**DANE COUNTY DEPT. OF  
PUBLIC WORKS, HIGHWAY &  
TRANSPORTATION**

# ADDENDUM

**RFB NO. 321041 - ADDENDUM NO. 01**

## **REQUEST FOR BIDS NO. 321041 ELECTRIC VEHICLE CHARGING STATIONS HUMAN SERVICES 1202 NORTHPORT DRIVE MADISON, WISCONSIN**

The following concrete detail added on sheet E3.0:

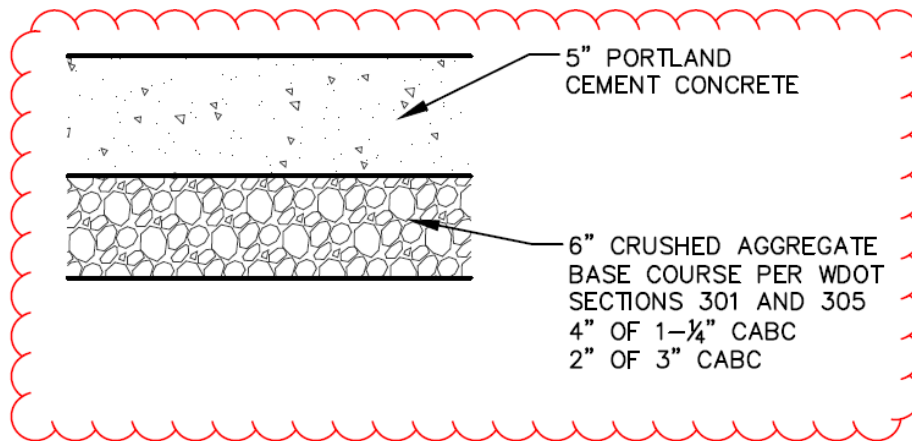
**4. All Sheets:**

Delete all sheets and replace with new sheets, issued with this addendum.

Revisions include:

“PRELIMINARY NOT FOR CONSTRUCTION” removed on all pages.
